PA945A SUPERSEDES PA945

OE number VW 036121008L replaces old OE numbers 036121005B and 036121005Q. Saleri has consequently developed PA945A that replaces the former reference PA945.

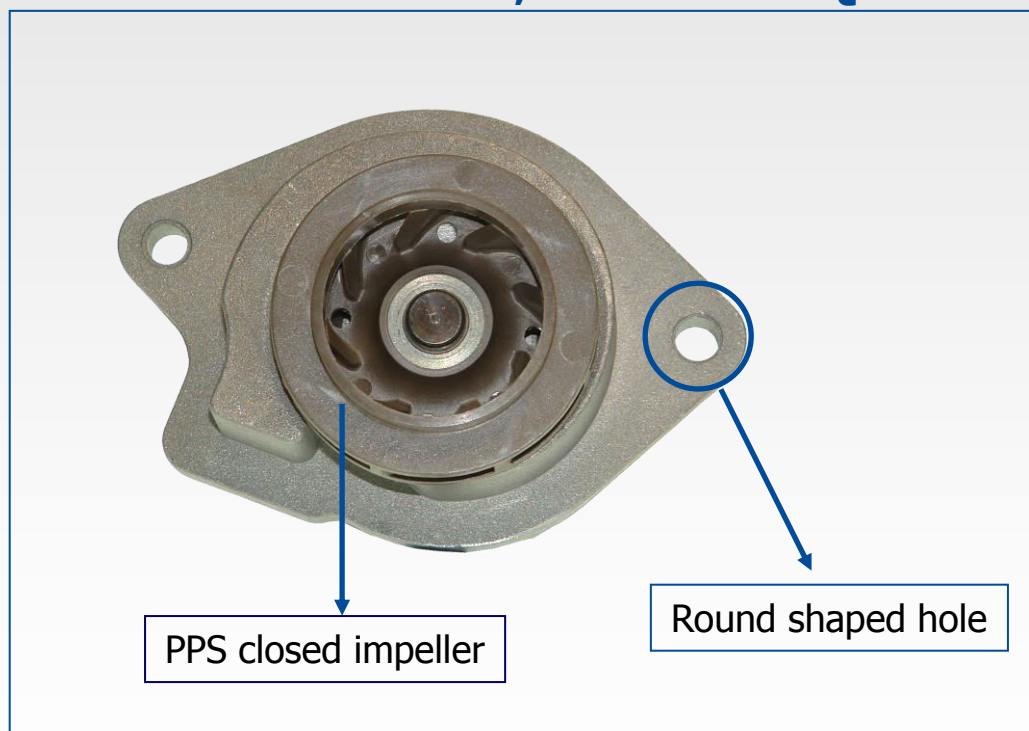
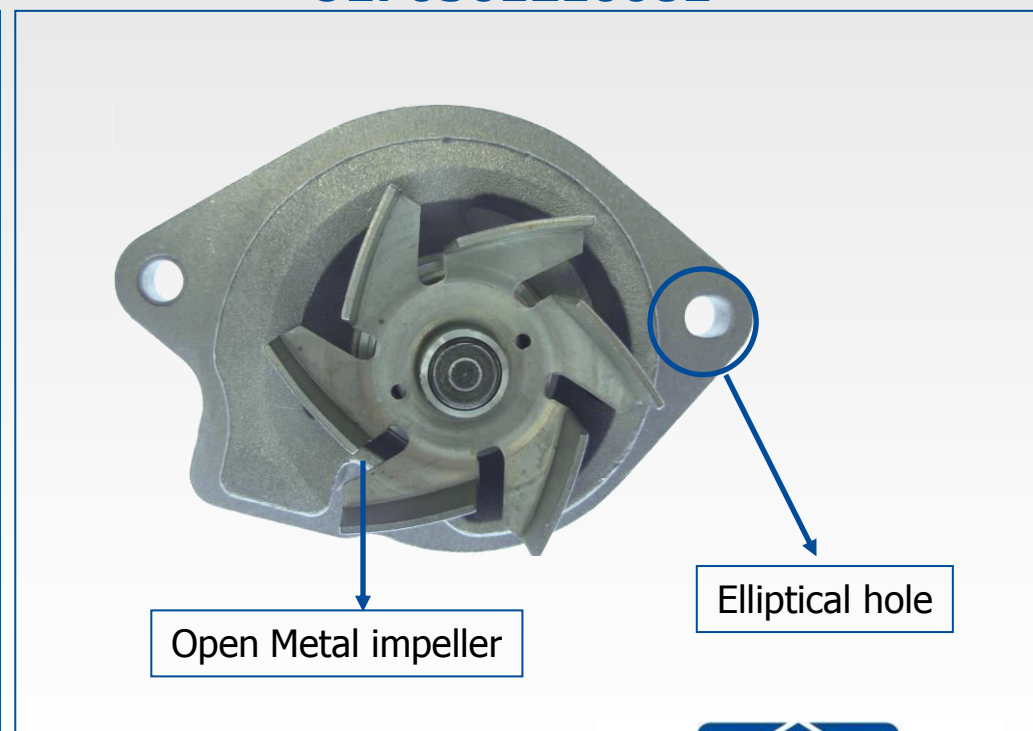
The main difference is the different geometry and material of the impeller.

A further difference can be noticed in the additional elliptical hole on the housing that allows an easier replacement and a better fitting to the applications linked to this reference
